MONTGOMERY COUNTY PLANNING BOARD
THE MARYLAND-NATIONAL CAPITAL PARK AND PLANNING COMMISSION

SUBJECT: Mandatory Referral MR2022012: MacArthur Boulevard Bikeway Segment 3:
Proposed sidepath and shoulder improvements

**HERITAGE TRIANGLE TRAIL – PHASE 1
DOCTOR BIRD ROAD/NORWOOD ROAD SIDEPATH
MANDATORY REFERRAL NO. 2022024**

Planning Staff recommends approval of the Heritage Triangle Trail – Phase 1 Sidepath 35 percent design plans (MR2022024) with the following comments.

Figure 12 – Plan view of the proposed Sidepath at the Entrance of Woodlawn Manor Cultural Park

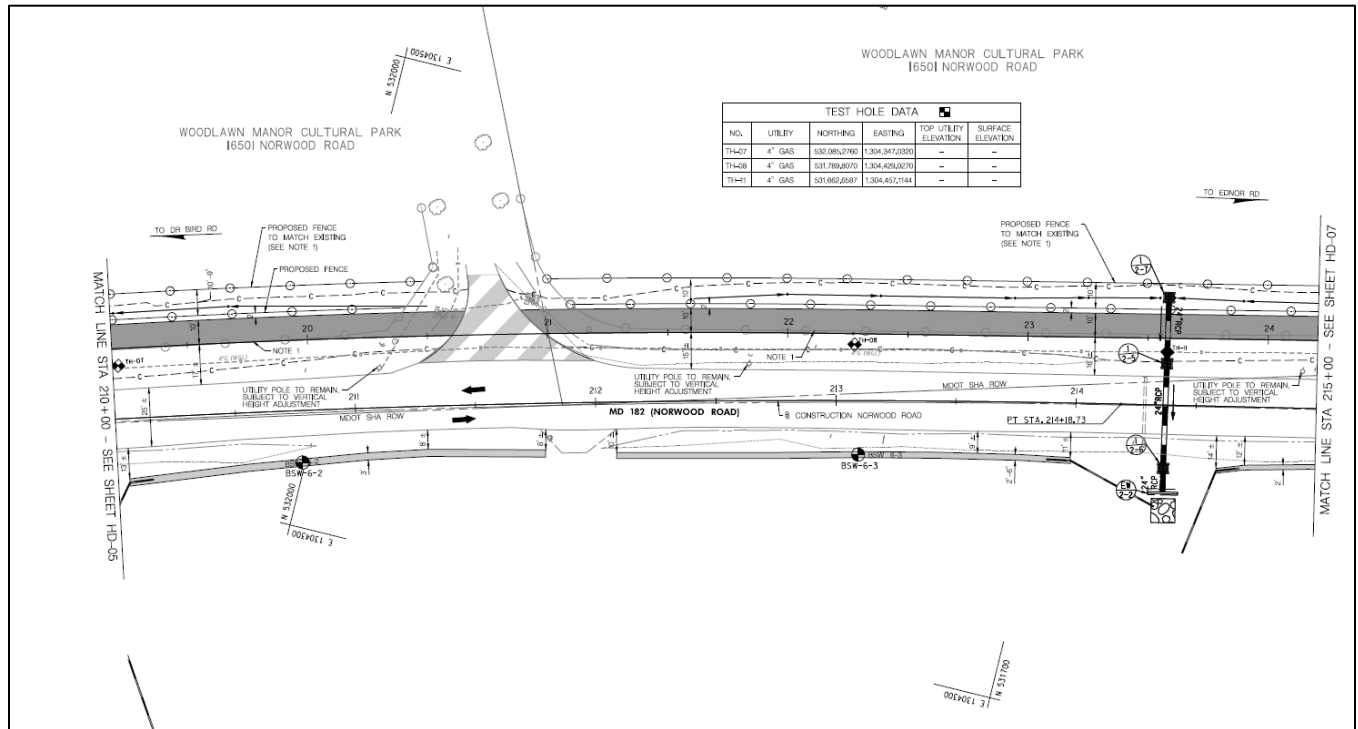
Montgomery Parks looks forward to the improved pedestrian and cycling access to Woodlawn Cultural Park, however the new path does present new challenges for safety and security. Figure 12 shows the proposed shared-use path plan view at the entrance to Woodlawn Manor. Parks Staff have noted concerns with the vehicular traffic utilizing this entrance as a cut-through and additional measures should be taken to improve the safety of the path crossing including better signage to reduce thru traffic, a marked crossing and detectable warning strips for pedestrian and cyclists, and other appropriate measures identified during detailed design. The existing signage at the entrance to Woodlawn will need to be relocated and replaced at the direction of Parks Staff.

Along the length of the east side of the path, at the request of Park Police, a double fence separated by a 10-foot width is proposed to separate the equestrian pasture from the path for the safety of both the

horses and path users. The fence must match the existing fence in design and materials. In addition, due to increased access and activity that the path will provide around the Park Police headquarters and equestrian facilities MCDOT will also provide four security cameras along the frontage of the Woodlawn Property. Finally, MCDOT will provide a trail counter along this section of the path to Parks' specification to allow for user data tracking and analysis.
